THIRD READING SUMMARY SHEET

ZONING CASE NUMBER: C814-88-0001.10 – Canyons @ Rob Roy Rezoning

ZONING CHANGE REVIEW SHEET

Staff recommends Planned Unit Development (PUD) zoning with the following changes to Exhibit "H" of the PUD Land Use Plan –

REDUCTION OF SHEET 3

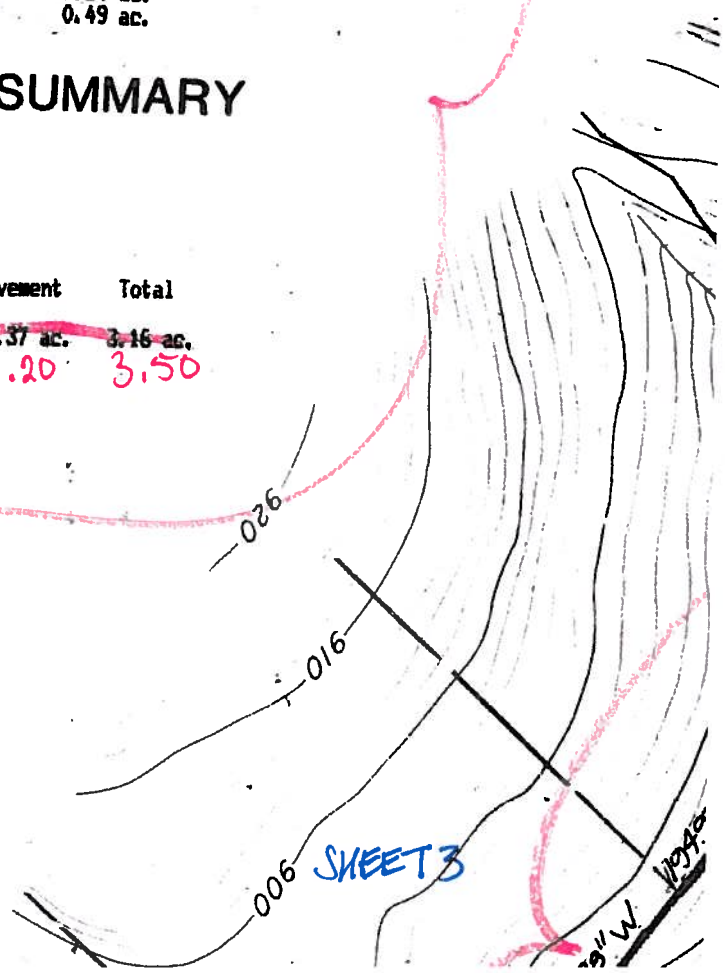
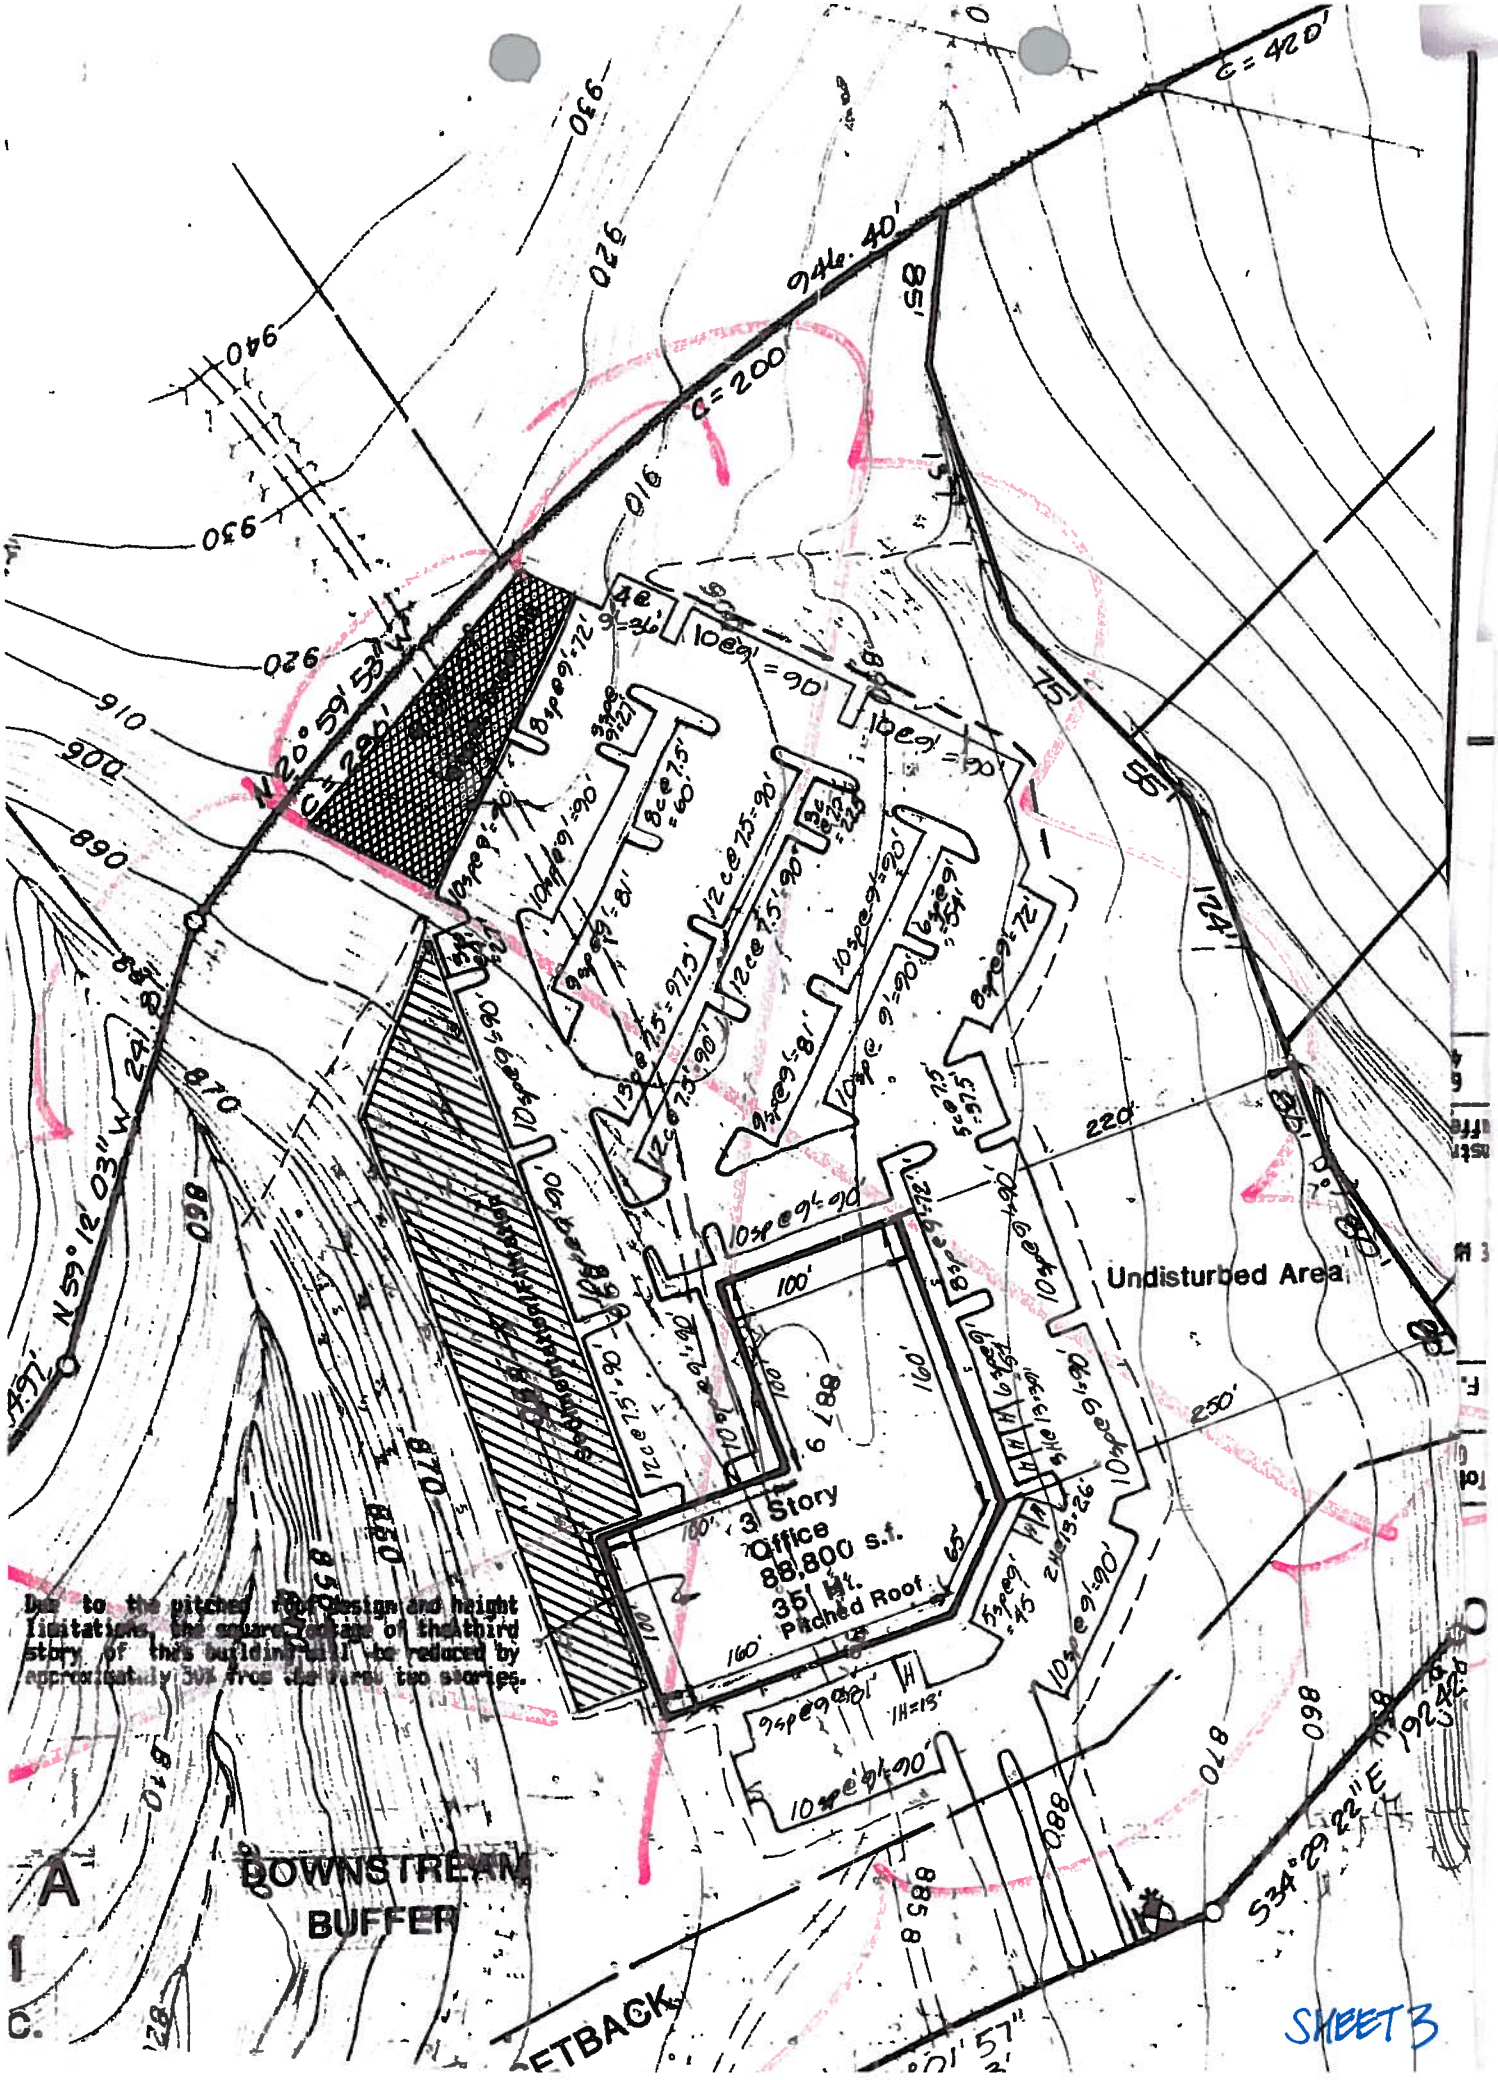
7. Remove the floor to area multiplier calculations and the allowable square footage calculations on Sheet 3.

8. Change the proposed impervious cover from 3.16 acres to 3.50 acres on sheet 3.

9. Change the Impervious Cover Summary Table on Sheet 3 to reflect the proposed impervious cover and to account for a different building configuration and parking layout.

10. Remove the Hill County Roadway Ordinance Table on Sheet 3.

11. Change the Comprehensive Watershed Ordinance Table on Sheet 3 to reflect the proposed impervious cover.

12. Remove the diagram on Sheet 3 of the office project.

13. Add a note on Sheet 3 that clarifies the maximum height allowed on Lot A-1 is 35 feet.

14. Remove the note on Sheet 3 that reads "Due to the pitch of the roof design and height limitations the square footage of the third story of this building will be reduced by approximately 50% from the first two stories.

Exhibit "H" Land Use Plan. Remove the floor-to-area multiplier calculations and the allowable square footage calculations on Sheet 3.

Exhibit "H" Land Use Plan. Change the proposed impervious cover from 3.16 acres to 3.50 acres.

Exhibit "H" Land Use Plan. Change the Impervious Cover Summary Table on Sheet 3 to reflect the proposed impervious cover and to account for a different building configuration and parking layout.

Exhibit "H" Land Use Plan. Remove the Hill County Roadway Ordinance Table on Sheet 3.

Exhibit "H" Land Use Plan. Change the Comprehensive Watershed Ordinance Table on Sheet 3 to reflect the proposed impervious cover.

Exhibit "H" Land Use Plan. Remove the diagram on Sheet 3 of the office project.

Exhibit "H" Land Use Plan. Add a note on Sheet 3 that clarifies the maximum height allowed on Lot A-1 is 35 feet.

Exhibit "H" Land Use Plan. Remove the note on Sheet 3 that reads "Due to the pitch of the roof design and height limitations the square footage of the third story of this building will be reduced by approximately 50% from the first two stories."

Justification: Per the Hill County Roadway Ordinance, the floor-to-area limitations only apply to nonresidential buildings.

Justification: While the proposed impervious cover is slightly more than the previous office project, this project is still under the 3.52 acres of impervious cover allowed for Lot A-1.

Justification: While the proposed impervious cover is slightly more than the previous office project, this project is still under the 3.52 acres of impervious cover allowed for Lot A-1. The prior office project proposed a vast amount of surface parking with a small building footprint. Since the use of the site is changing from office to multifamily, the size and configuration of the building and parking area must also change to accommodate a more user friendly development. The proposal is to provide a wrapped product type with structured parking within.

Justification: Per the Hill County Roadway Ordinance, the floor-to-area limitations only apply to nonresidential buildings.

Justification: While the proposed impervious cover is slightly more than the previous office project, this project is still under the 3.52 acres of impervious cover allowed for Lot A-1.

Justification: Zoning is used to establish the best use for a site and should not be used to dictate the location of site improvements. This should be deferred to the site development stage when engineered documents and related reports are available to assess the proper location of improvements based on site constraints. Removing the diagram from the land use plan also

Justification: This note is unnecessary since the building is limited to 35 feet with height limit exceptions, as prescribed by 25-2-531 of the City Code, for certain architectural elements including pitched roof designs.
